Proj. 5-8
Docket 70-36

Mallinckrodt's 7/8/60 proposed bridge
for 8" U₂ cylinders.

Adjacent ~~cylinders~~ spheres!

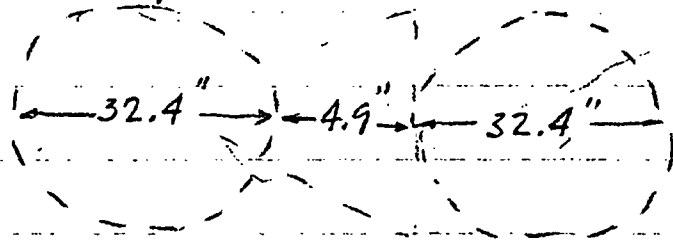
Mallinckrodt uses the cylindrical shape
in determining Ω , and comes out with
values of 1.39 and 2.37 steradians. How-
ever, item 3C(2) specifically says that
interaction in this case is to be
computed on the basis of the mass being
contained in a spherical volume of
 $H/U = 800$.

For 12.5% enrichment, assume that most of volume of sphere is taken up by water at an $H/U = 800$

$$\therefore \text{In a cylinder, grams H}_2\text{O} = \frac{800(9,600)(18)}{(2)(235)} = 294,000$$

$$294 \text{ liters} \times \frac{61 \text{ in}^3}{\text{liter}} = 18,000 \text{ in}^3$$

$$\therefore r^3 = \frac{18,000}{\frac{4}{3}\pi} = 4,280 \rightarrow r = 16.2 \text{ inches}$$

$$\Omega = 2\pi(1 - \cos\theta); \quad \tan\theta = \frac{16.2}{16.2 + 4.9} = 0.767$$

$$\therefore \cos\theta = 0.793$$

$$\Omega = 2\pi(1 - 0.793) = 2\pi(0.207) = 1.3$$

Recalc. of Ω using cylindrical geometry (Adjacent cylinders):

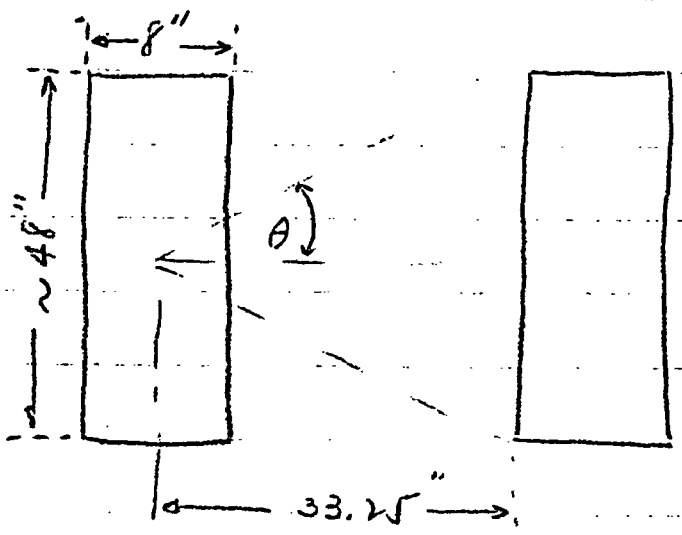
$\rho_c = 37 \frac{1}{4}$ " approx $\sim 55^\circ$

$$\Omega = \frac{2d}{h} \sin \theta$$

$$\tan \theta = \frac{24}{33.25}$$

$$\therefore \sin \theta = 0.585$$

$$\therefore \Omega = \frac{16}{33.25} (0.585) = 0.281$$

(Diagonal cylinders):

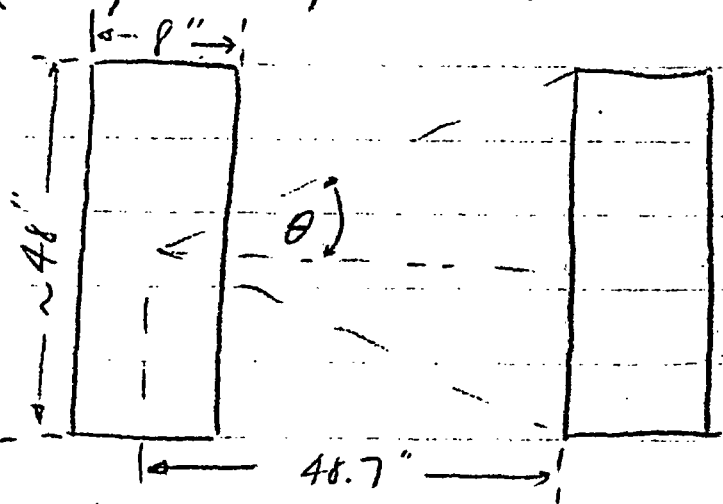
$$\tan \theta = \frac{24}{48.7} = 0.493$$

$$\therefore \sin \theta = 0.442$$

$$\therefore \Omega = \frac{16}{48.7} (0.442)$$

$$\Omega = 0.145$$

$$\begin{aligned}\therefore \Omega &= 3(\text{adjacent cyles.}) + 2(\text{diagonal}) \\ &= 3(0.281) + 2(0.145) = 0.844 + 0.290 = 1.13\end{aligned}$$

(checks 1.39 steradians calc. by MCW fairly well, as they have also included very remote containers).
